BRIDGE RAILING ELEVATION

APPROVAL DRAWING

REV.	CHK'D	BY	DATE	REMARKS
PAY ITEM 525.33 NETC-2-RAIL				
STATE OF VERMONT AGENCY OF TRANSPORTATION TOWN OF MADISON, VT STRATFORD, NH PROJECT NO. NH BHO-1447-(24)				DRAWN MARLEY CHECKED SAR APPROVED
CUSTOMER WINTERSET INC		P.O. No. C-1308		DATE 3/4/04
TRINITY INDUSTRIES, INC. HIGHWAY SAFETY PRODUCTS 2525 STEMMONS FREEWAY, DALLAS, TX 75207				ENG. FILE # 22-1032196 SHT. No. E1 OF 3 TRINITY SALES ORDER NO. (22)1032196 REV. 0

SPAN 1 RAIL POST

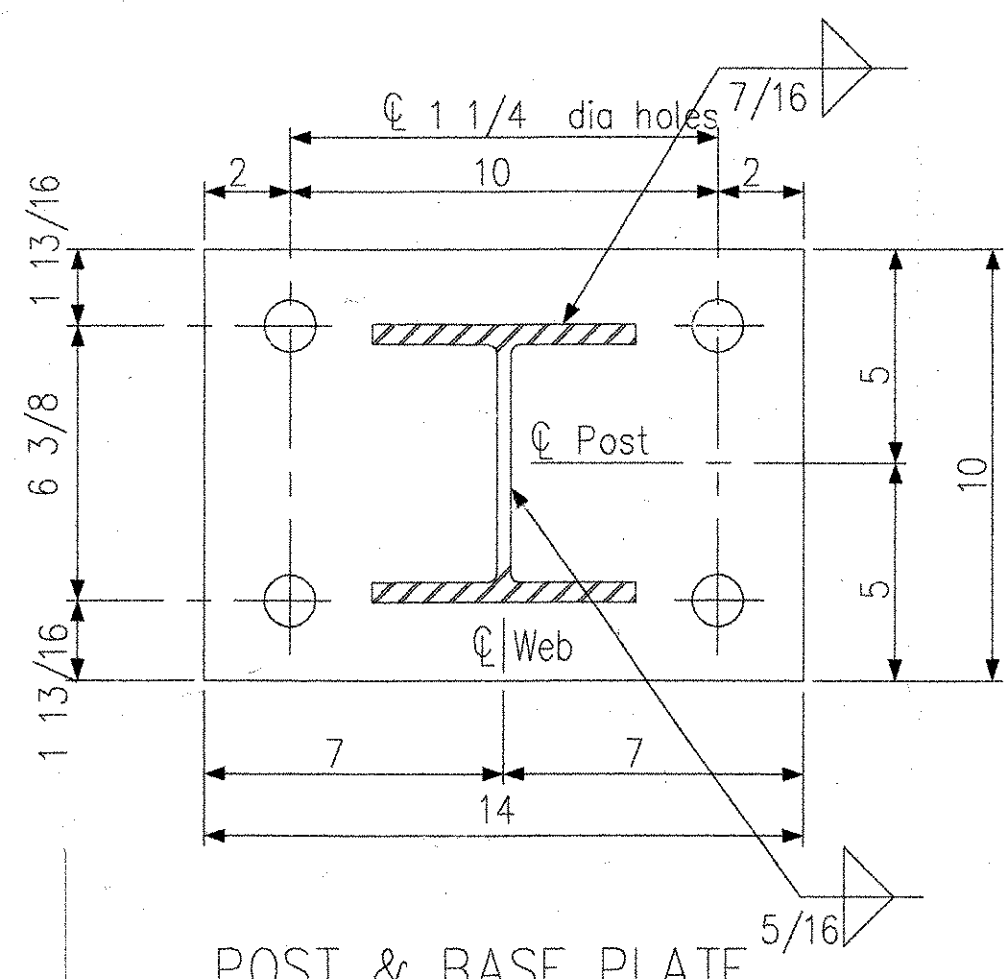
Holes in rails shall be field drilled and to be 1/8 larger than connection bolts.
3/4 dia x 6" round head bolt w/ washer & locknut
